NO.	REVISIONS DURING BIDDING	APPV'D.	DATE
△1	REVISION	RPC	7/18/16

CONTINENTAL RANCH
REGIONAL PUMP STATION
UPGRADE DESIGN
LOWER LEVEL ELECTRICAL
POWER AND LIGHTING PLANS

SHEET NO. : E104
75 OF 91

LOWER LEVEL ELECTRICAL POWER PLAN

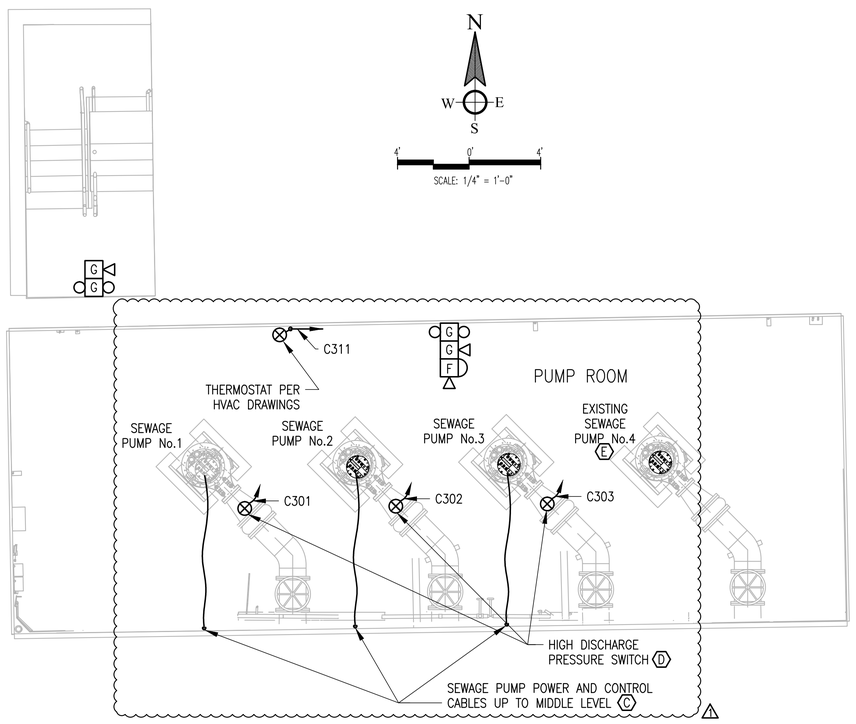
E. REROUTE EXISTING PUMP 4 CABLES THROUGH CEILING TO AMTCH PUMPS 1, 2 AND 3 CABLE ROUTING, SEE KEYNOTE C. △1
